## Power Divider Lockout Leakage, Repair CHU, GU, LEU, LR, MRU, CXU, TD

### FSB 468-001, Power Divider Lockout Leakage, Repair

(March 2016)

W4111064

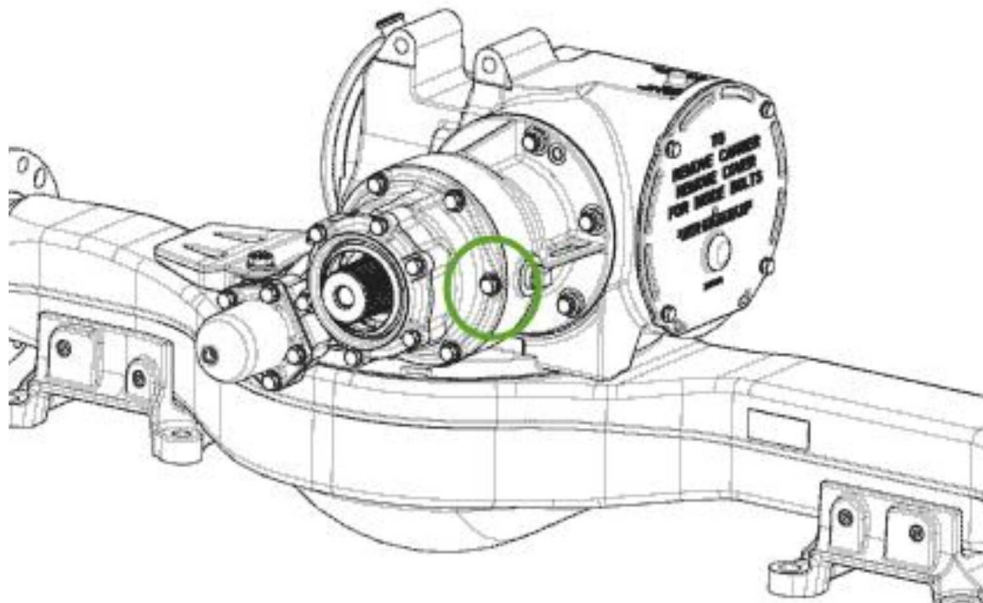
On MACK vehicles built between July 6, 2015 and January 15, 2016 equipped with a MACK CRD 150 carrier, the mounting bolt hole on the driver side of the power divider housing which lines up with the fill plug is drilled through to the fill plug hole. This can create a path for a leak around the threads of the mounting bolt. The remaining five mounting bolt holes are blind. When a leak is found in this area, verify that all six mount bolts around the flange are tight. If any of the mounting bolts are found to be loose, the power divider lockout (PDLO) assembly must be removed and the gasket replaced. If all the bolts are tight, the bolt at the 3:00 position should be removed and cleaned along with the mounting hole with a residue free cleaning spray like contact cleaner.

**Note:** Starting January 15, 2016 production has moved to a flange headed bolt with pre-applied sealant on the bolts for the power divider lockout similar to the bolts used on the non-power divider lockout units. If there is a leak in this area on a vehicle built after January 15, 2016 there is a different problem.
